SB-10060338-2610

BRAKE HOSE INSPECTION

Prevost vehicles

Figure 2

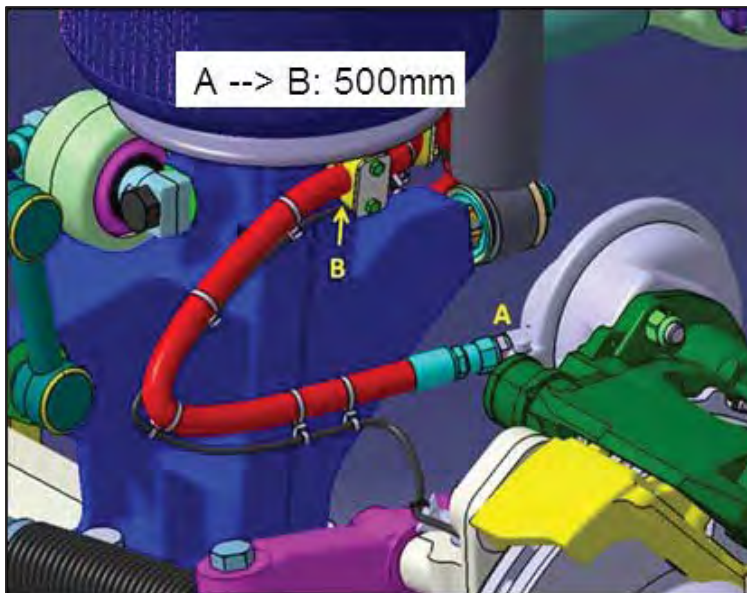
3. If there is interference, reposition the hose on each side of the vehicle as shown in fig. 2 and 3.

4. Measure and mark distances below on hose and adjust hoses as required to avoid interference.
 - From A to B: 500mm (19 5/8")
 - From B' to C: 390mm (15 3/8")
